**ADDENDUM TO REPORT OF NEAL McCARRY,
SERVICE UNIT MANAGER STRATEGIC PLANNING
DATED 26 AUGUST 2024**

SUBJECT: ITEM N0.10.4 - NSW Government's Crows Nest Transport Oriented Development rezoning proposal

Submission to the Department of Planning, Housing and Infrastructure

Crows Nest Transport Oriented Development (TOD) rezoning proposal

Figure C1.1 Concept SSDA (2018) – two residential towers

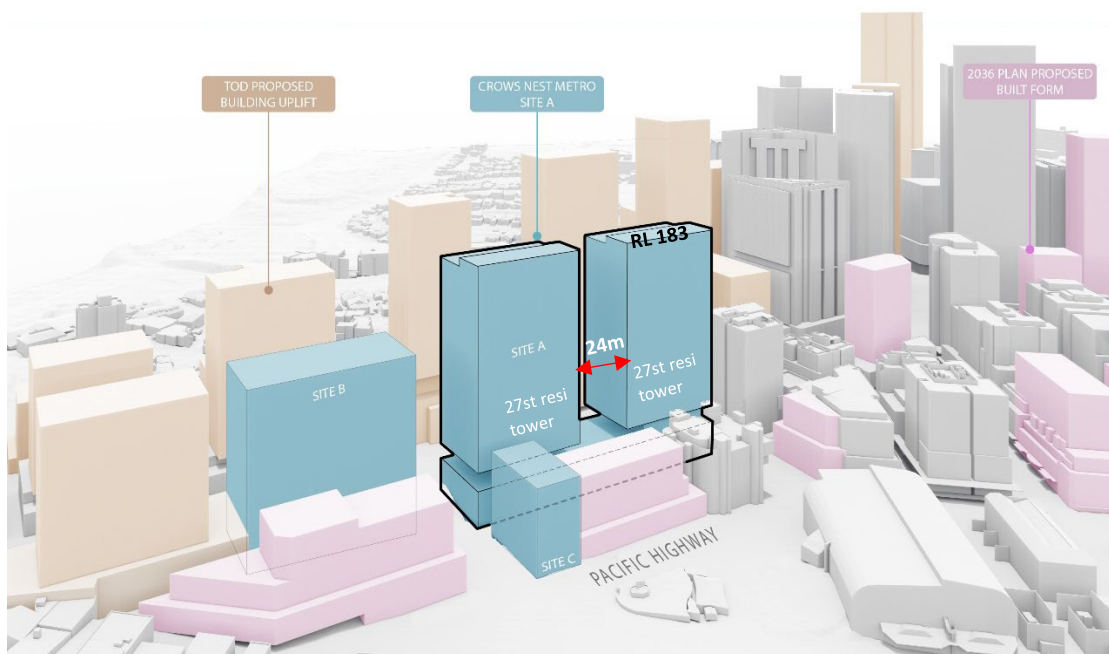
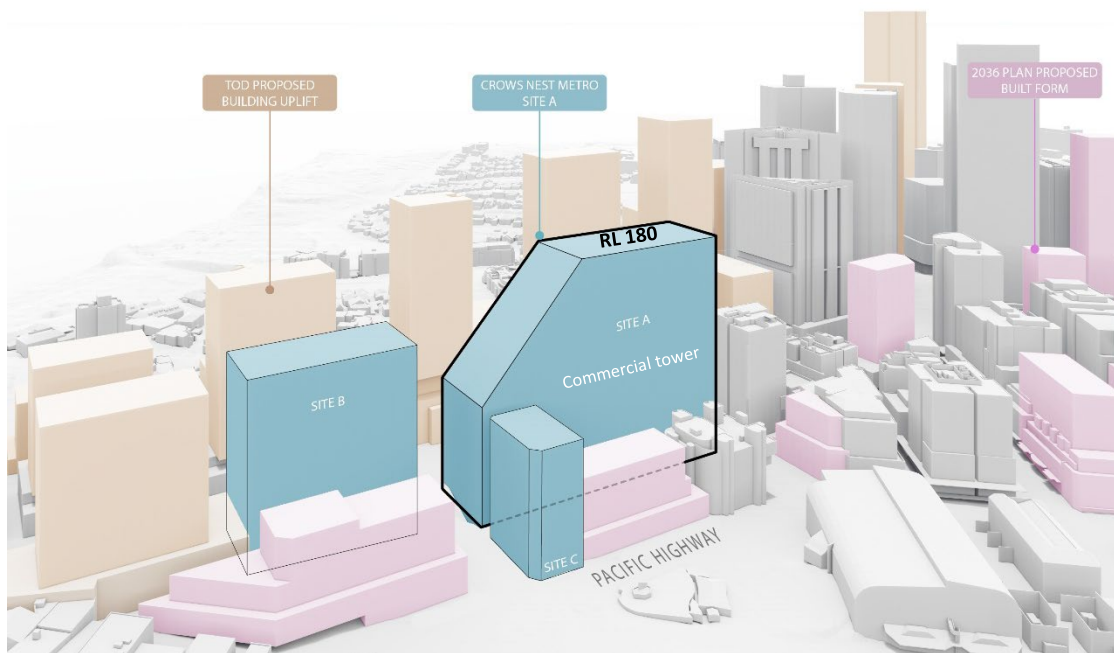
- **Concept SSDA (2018):** The proposed concept scheme included a mixed use development up to 27-storeys in height, with a commercial base and two residential towers with 24m tower separation (refer to Figure C1.1) above. The key concerns raised by Council at the time in relation to the Concept SSDA included:
 - the proposed built form being out of scale with the fine-grain nature and village atmosphere of Crows Nest
 - the extent of overshadowing impacts to Ernest Place and Willoughby Road
 - the limited employment opportunities and public benefits for the area.

- **Approved building envelope (2020):** In 2020, the NSW Government finalised the 2036 Plan and subsequently amended NSLEP 2013, by implementing the approved built form envelope in terms of building height, FSR and Non-residential FSR for the Crows Nest Station OSD SSDA (refer to Figure C1.2). The proposed increase in non-residential FSR was supported as it provided a significant boost in employment floor space compared to the original SSDA scheme. The main concerns raised by Council in relation to the approved building envelope were:
 - the bulk and massing of the built form negatively impacting the village atmosphere of Crows Nest
 - the overshadowing impacts to Ernest Place and Willoughby Road
 - the domination of the continuous long and tall façade with no gaps or articulation, creating an uncomfortable environment for pedestrians.

Figure 1.3: Crows Nest TOD (2024)

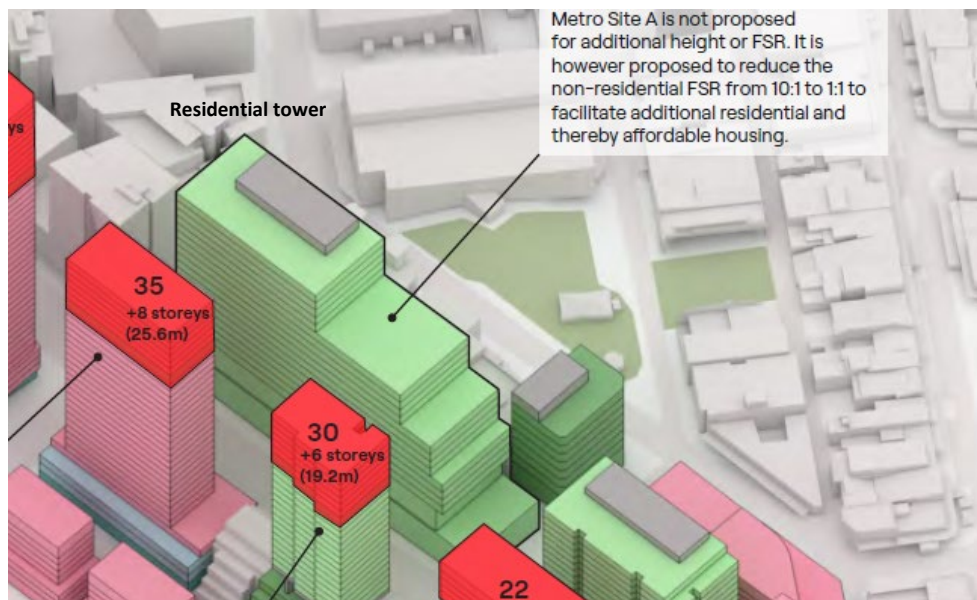
Package suggests that the built form for Site A will remain as a single tower with a significantly long unbroken façade parallel to the Pacific Highway (refer to Figure C1.3). The key concerns arising from the implementation of the proposed affordable housing incentives on Site A include:

- the scale and massing of the building diminishing the village character of Crows Nest
- the overshadowing effect to Ernest Place and Willoughby Road
- the extensive length of the façade, which lacks any breaks or articulation, overwhelms the street frontage and creates an unwelcoming experience for pedestrians
- the significant decrease in employment floor space, thereby restricting employment opportunities to a highly accessible site and could negatively affect the long-term economic vitality of the region and local area.

Figure C5.3: Sun eye diagram at 4.10pm on 21 Sep - Ernest Place

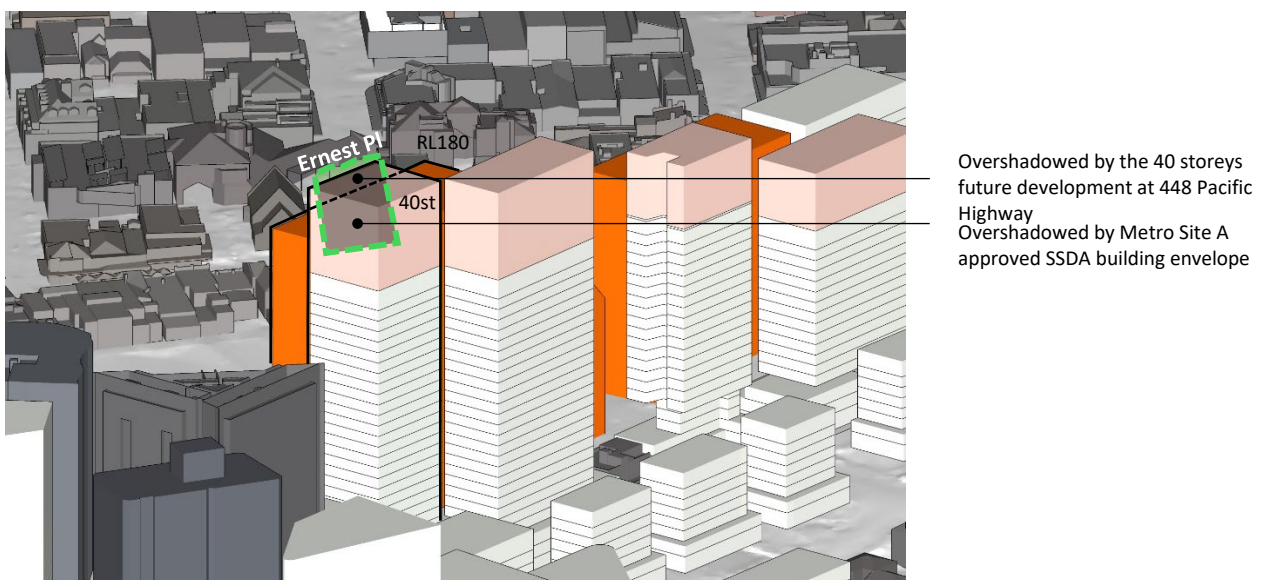
If the affordable housing incentives are taken up at 448 Pacific Highway, it will create additional overshadowing impact to Ernest Place and Willoughby Road, beyond the anticipated impacts of the envelope to Site A of the Crows Nest Metro OSD (refer to Figure C5.3). This additional overshadowing impact is unacceptable as the approved Crows Nest Metro OSD building envelope already creates significant shadow impacts and visual impacts to Ernest Place and Willoughby Road within the Crows Nest village.

It is recommended that the State Government collaborate with Council to refine the planning controls for 448 Pacific Highway and Site A to the Crows Nest Metro OSD to reduce the overshadowing impacts to Ernest Place and Willoughby Road.

Figure E4.1: NSC model of proposed affordable housing bonus heights (Source: North Sydney Council)

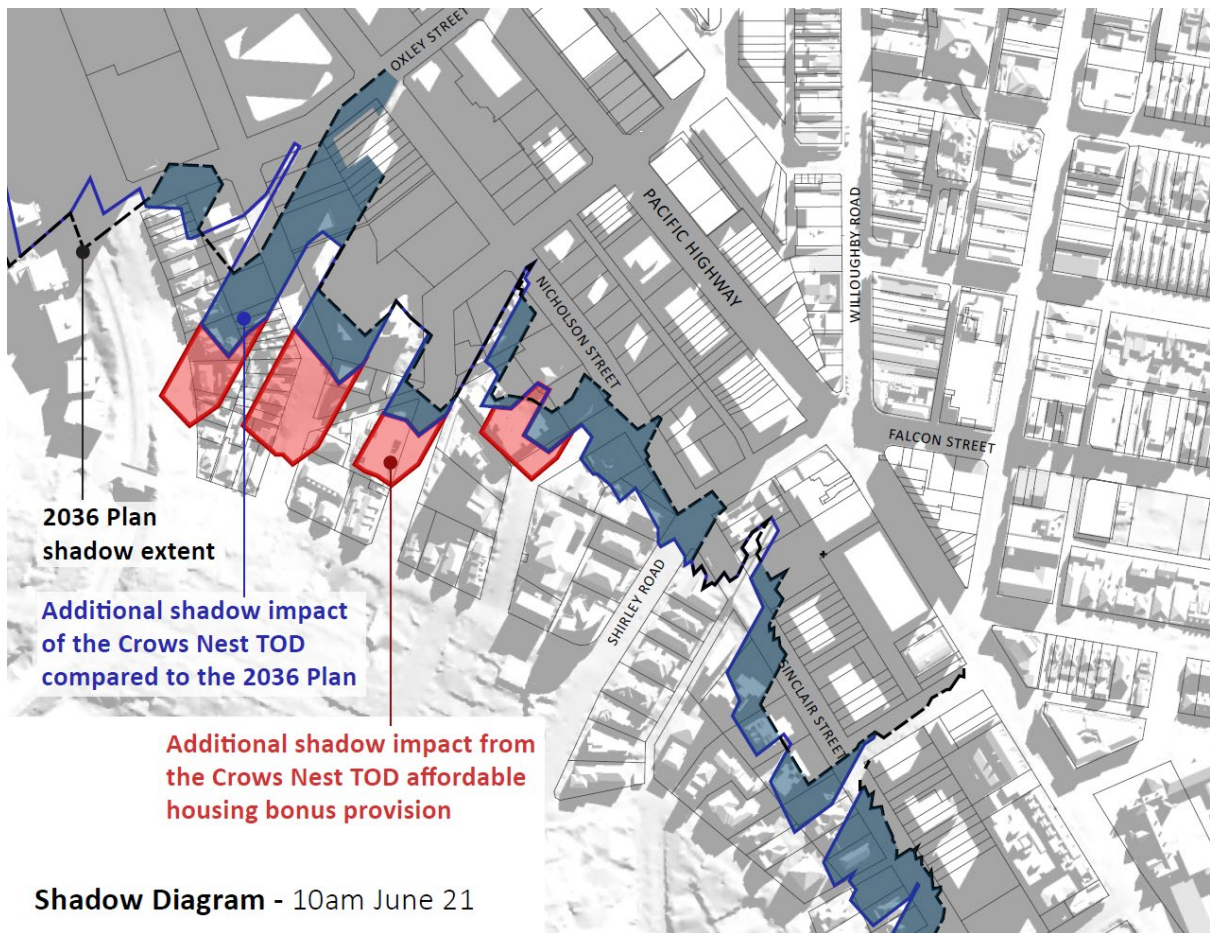
The impacts of the affordable housing incentive bonuses for the four key sites on the south-western side of the Pacific Highway opposite the Sydney Metro station, have been modelled to analyse the shadow impact of the various proposed building heights (Figure E4.1 and E4.2).

Figure K7.1. Right hand turn bans and the existing road network design will encourage rat-running through local streets.

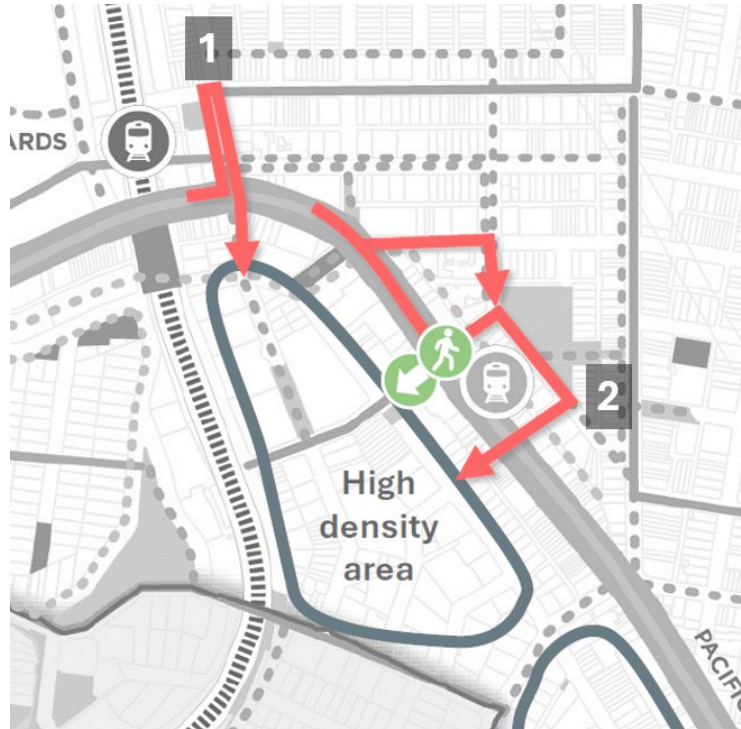
There are existing 'No Right Turn' restrictions for southbound traffic on the Pacific Highway into Hume Street or Shirley Street. Drivers travelling from the north to the proposed uplifted area on the western side of the Pacific Highway will attempt short-cut routes through residential streets to gain access (see Figure K7.1).

This is of concern particularly for the areas that are expected to experience increased pedestrian activity as a result of the Crows Nest Metro Station and increased traffic due to current and planned rates of off-street parking provision within new development. Potential amelioration measures that warrant investigation include:

- removal of the roundabout at the intersection of Chandos Street and Christie Street (identified as point 1 in Figure K7.1) to reduce this travel pattern.
- treatments to minimise through traffic on Hume Street crossing the Pacific Highway (identified as point 2 in Figure K7.1)
- traffic calming measures for the entire precinct to prevent short-cut through movements through local streets. This should include continuous footpath treatments and raised pedestrian crossings on Oxley Street and Clarke Street.
